1997 - 1998, 2000 Corvette: Service Bulletin: Electronic Steering Column Lock May Refuse to Operate - DIC Service Message Displayed

Number: 01-02-35-008

Subject: Electronic Steering Column Lock May Refuse to Operate - DIC Service Message Displayed (Update Column Lock Wiring, Install Revised Relay and/or Replace Electronic Column Lock)

Model Year: 1997-1998, 2000 Chevrolet Corvette Built Between the Following VIN Breakpoints:

ECL Disconnect: 1997, 1998 and 2000 Models with Automatic Transmission (Domestic)

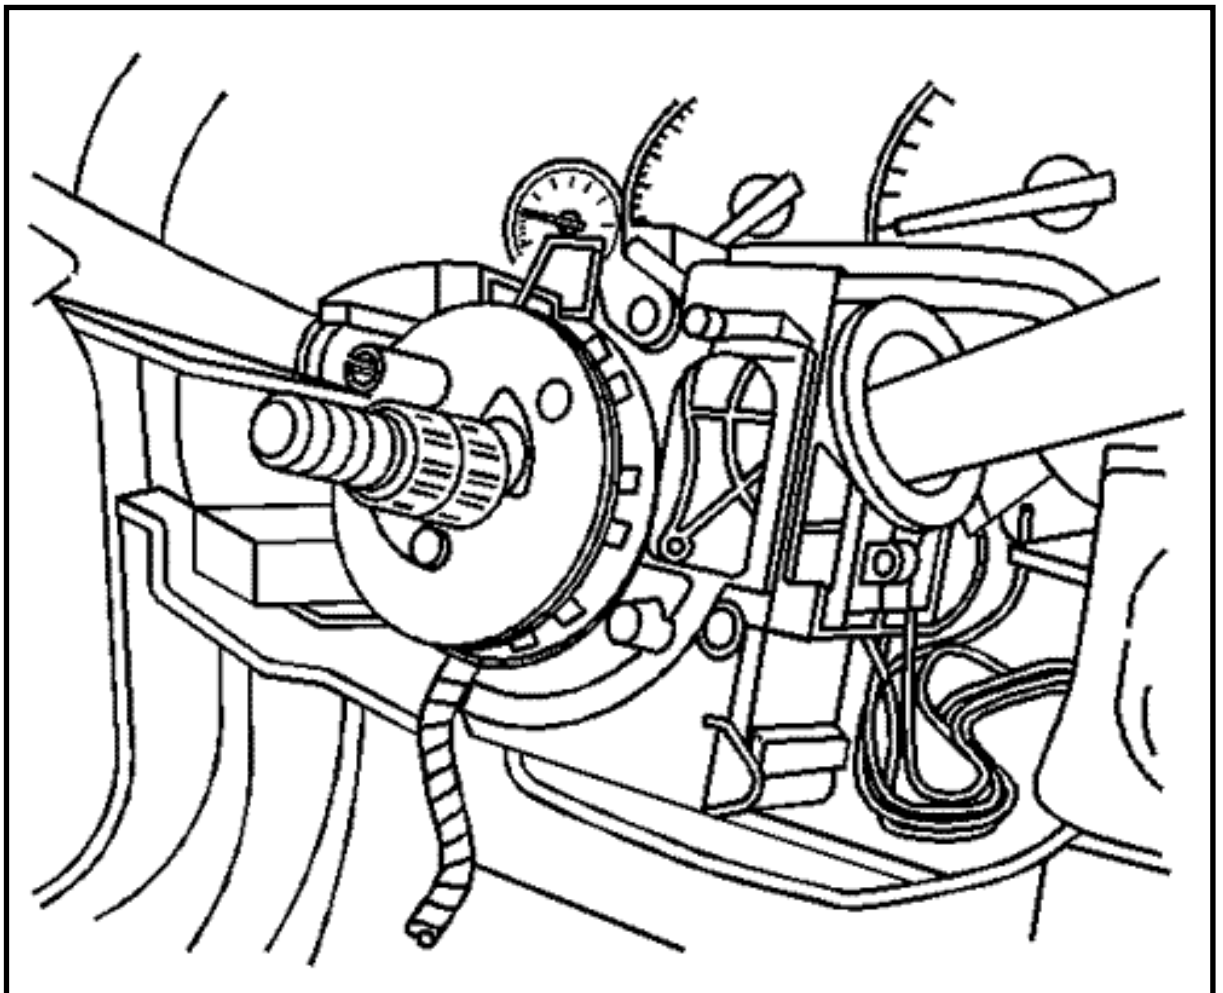
1. Disconnect the negative battery cable.
2. Disable the SIR module. Refer to Disabling the SIR System in the SIR sub-section of the Service Manual.
3. Remove the driver's side SIR module from the steering wheel.
4. Remove and discard the steering wheel set nut.
5. Using J 1859-A and J 42120, remove the steering wheel.
6. Remove the tilt steering lever.
7. Remove the combination trunk release and fog light switch.

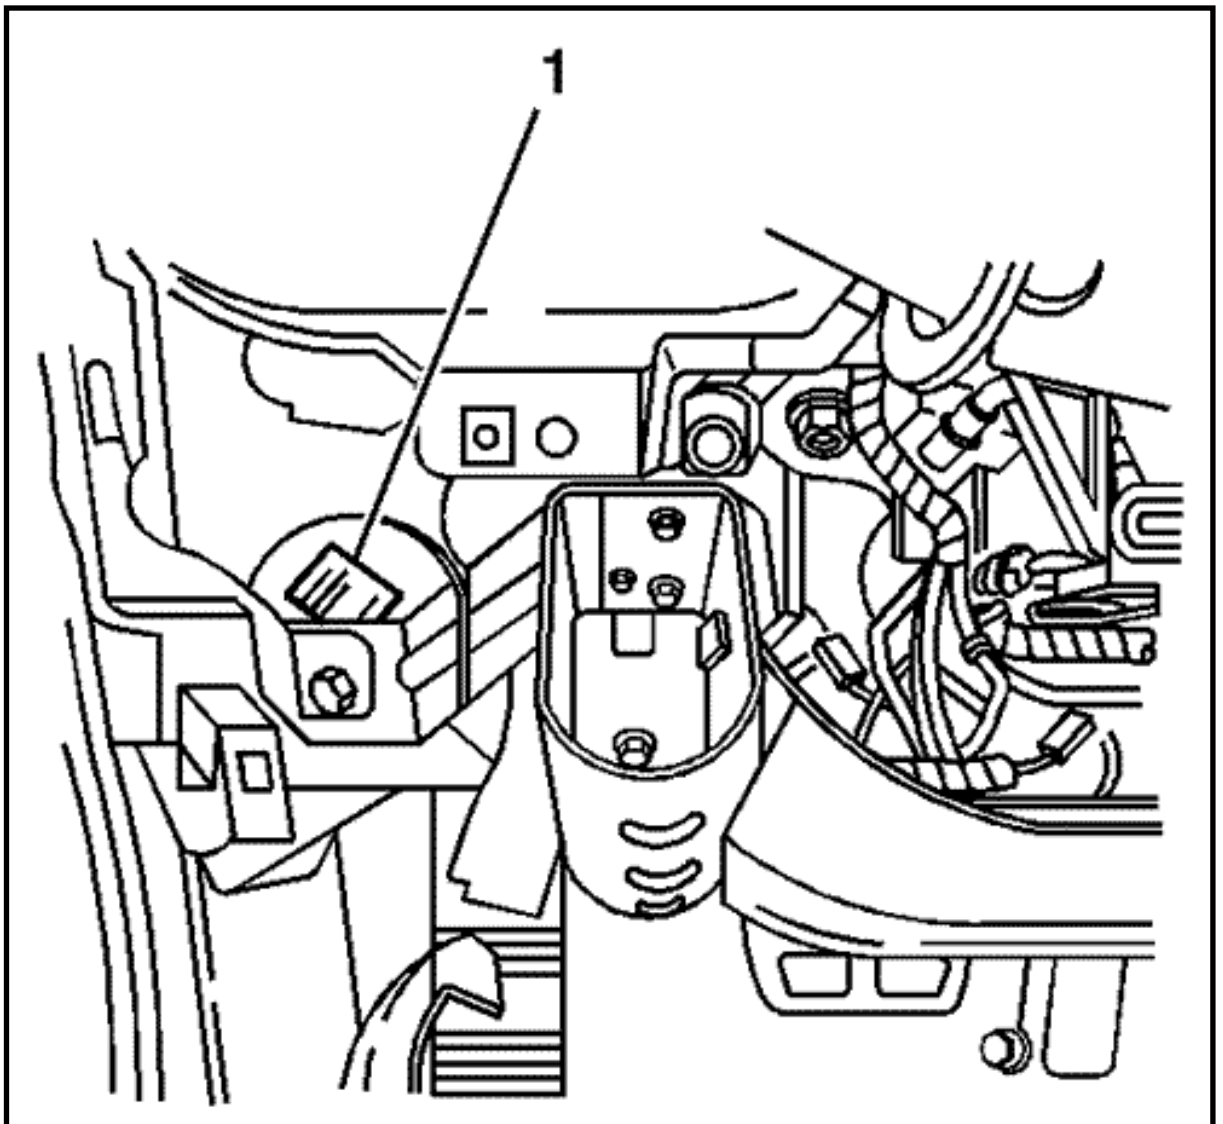
12. Remove and discard the Steering Column Lock/Cam Orientation plate

using the J 38364.

13. Install the included Cam Orientation Plate and secure with a new locking ring, using J 42137 and J 38364 as shown.
14. Install the SIR coil and secure with snap ring.
15. Disconnect the connector from the ECL (located on the right lower side of the steering column) to the I/P main harness.

ECL Upgrade: 1997,1998 and 2000 Models with Manual Transmission or Export Vehicles

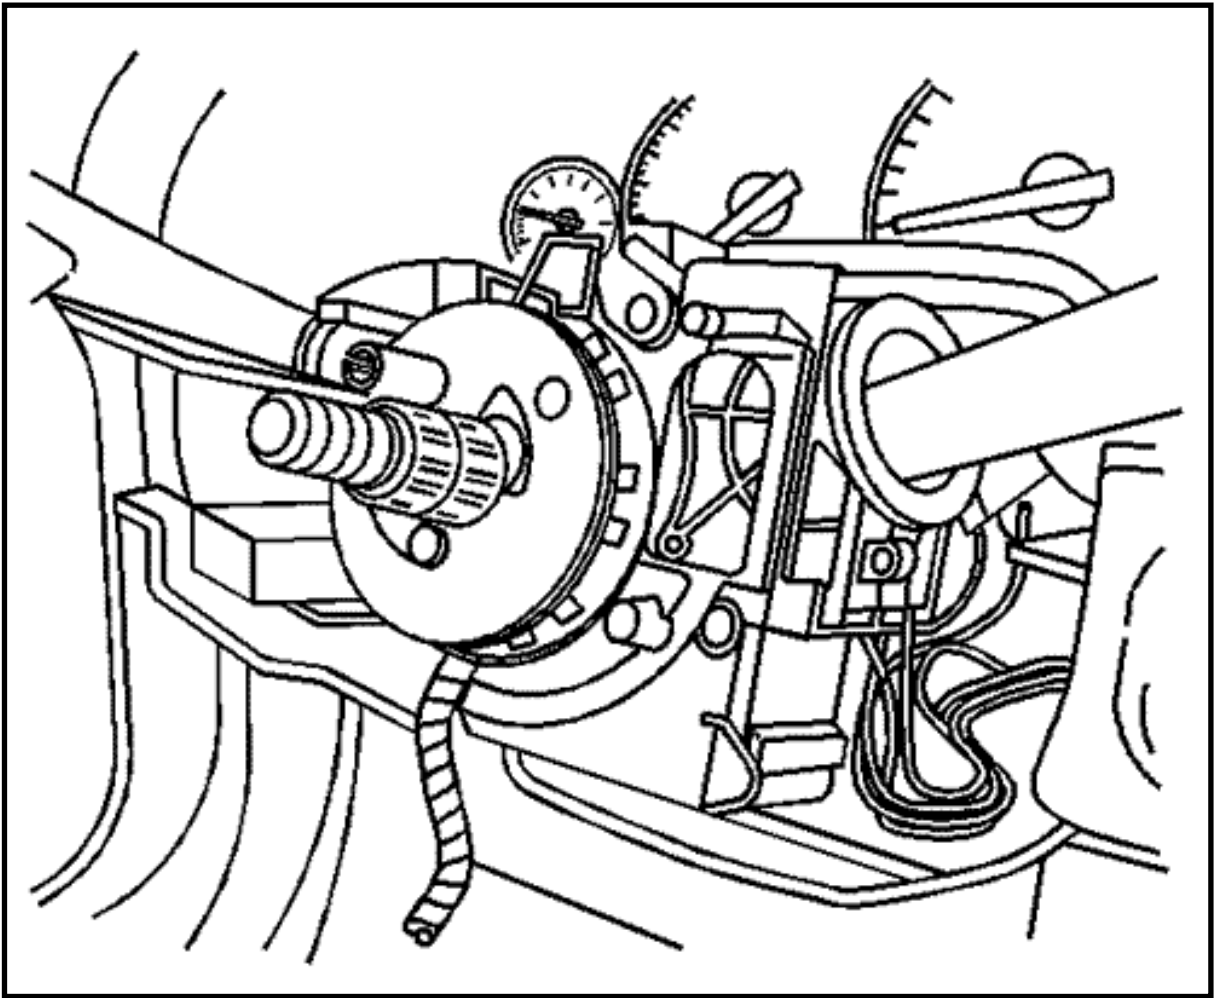
In order to complete the repairs for the vehicles referenced above, you must order P/N 26056108 Nut, Steering Wheel and P/N 26050960 Lock, Strg Whl Theft Dtrnt.

1. Disconnect the negative battery cable.
2. Disable the SIR module. Refer to Disabling the SIR System in the SIR sub-section in the Service Manual.
3. Remove the driver's side SIR module from the steering wheel.
4. Remove and discard the steering wheel set nut.
5. Using J 1859-A and J 42120, remove the steering wheel.
6. Remove the tilt steering lever.
7. Remove the combination trunk release and fog light switch.

FIGURE 1997 and 1998 (early) Manual (U.S. & Canada and All Export (Manual & Auto)(c)

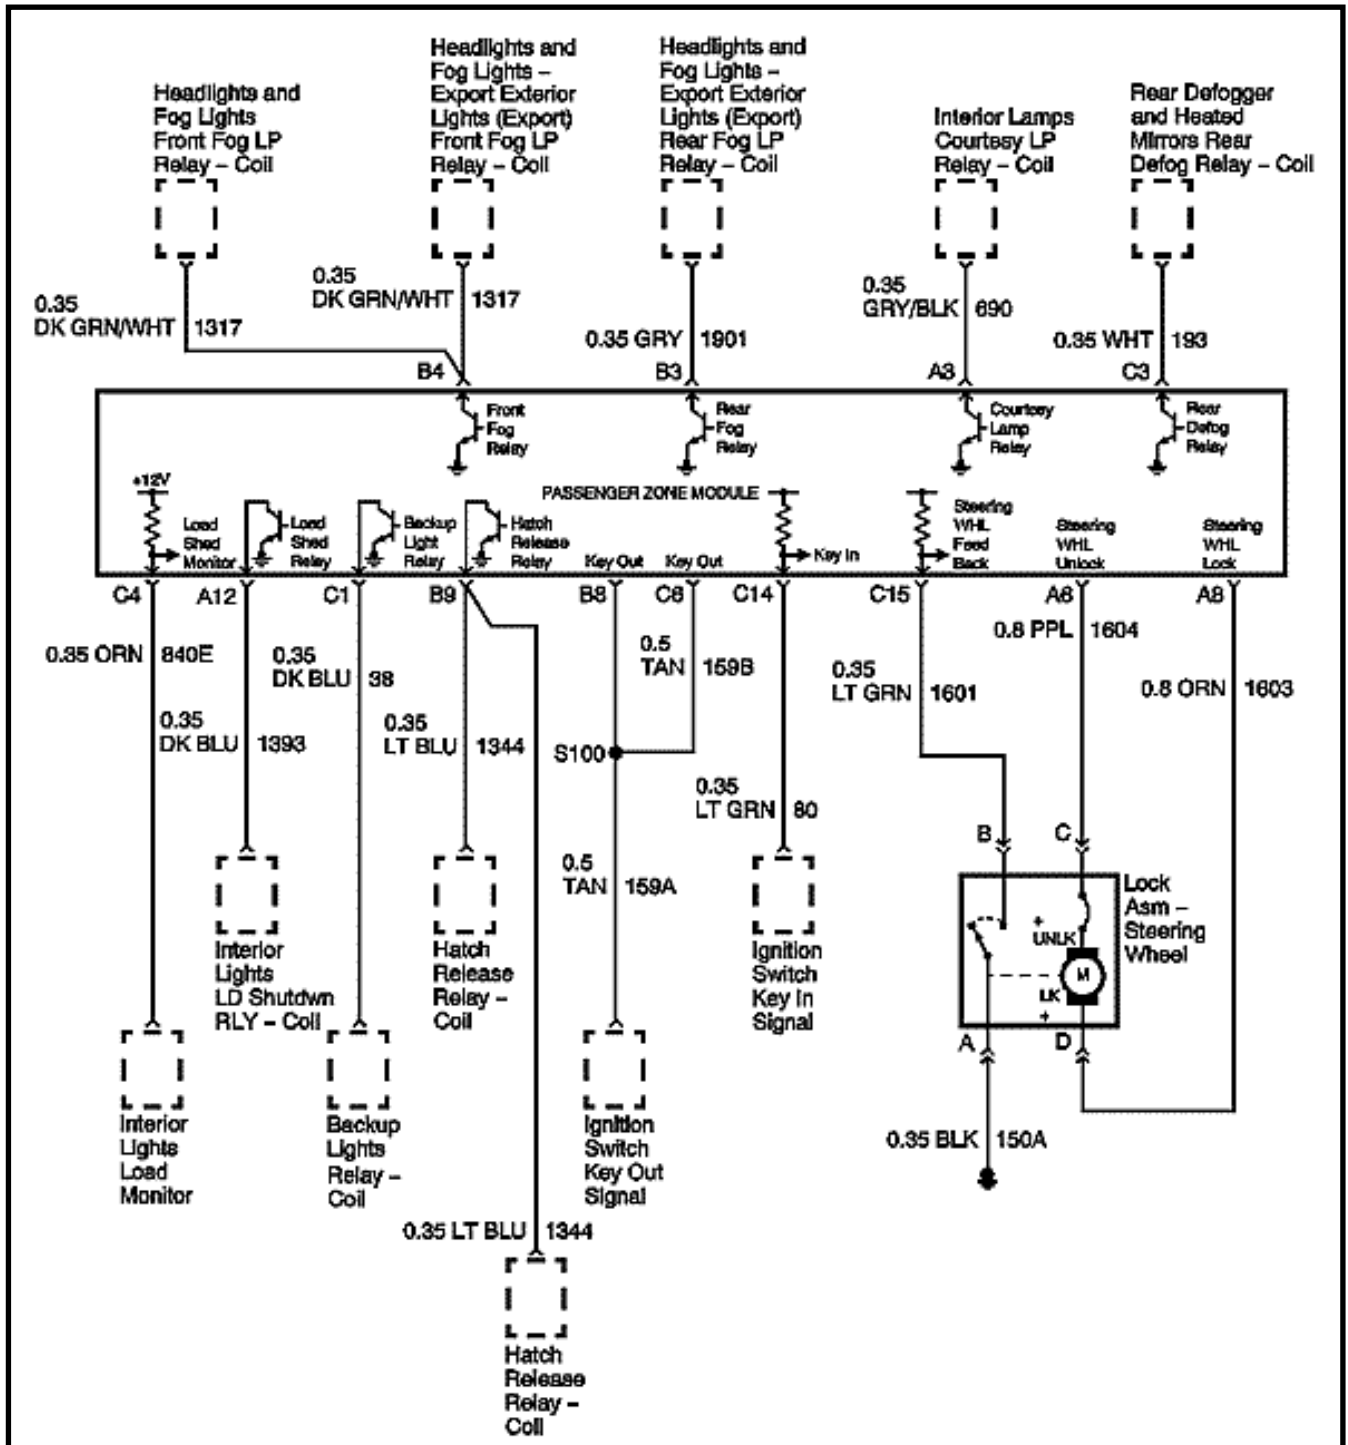
- **When removing the driver's side knee bolster trim panel as described below, care must be taken not to damage the console trim plate as the knee bolster trim panel tucks in behind the console trim plate.**
- **Revised schematics are included to aid and/or verify the proper installation of the service kit.**

FIGURE 2000 (late) Manual and All Export (c)

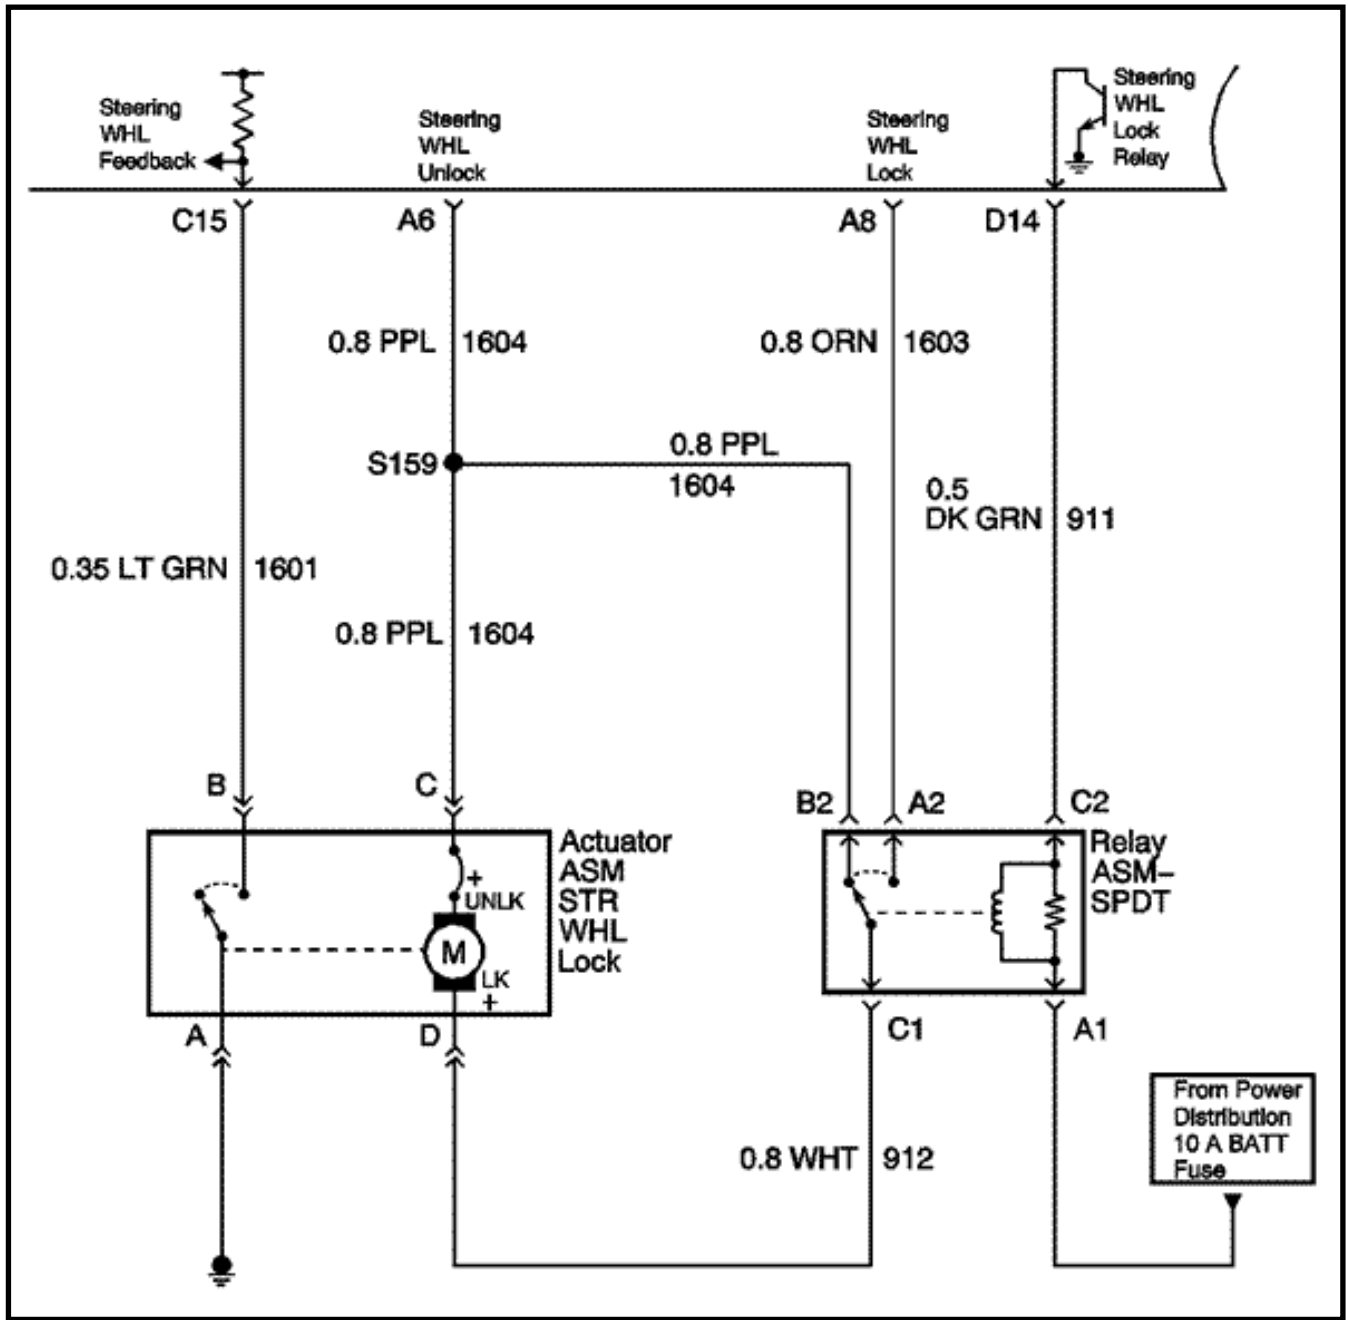
- **In order to complete the wiring upgrades listed in the section, you will need to order P/N 88952428, Wire Kit, Strg Wheel Theft Dtrnt.**
- **You may use the included schematics to aid in verifying the installation of the new relay and jumper wire.**

12. Remove the white wire from position A2 on the ECL relay connector.
13. Swap the two terminal positions and re-insert, orange wire to A2 and white wire to C1.

14. Add the new purple wire from the jumper to terminal position B2.
15. Install the new single pole, double throw relay.
16. Install the Green 16-way connector to the BCM.
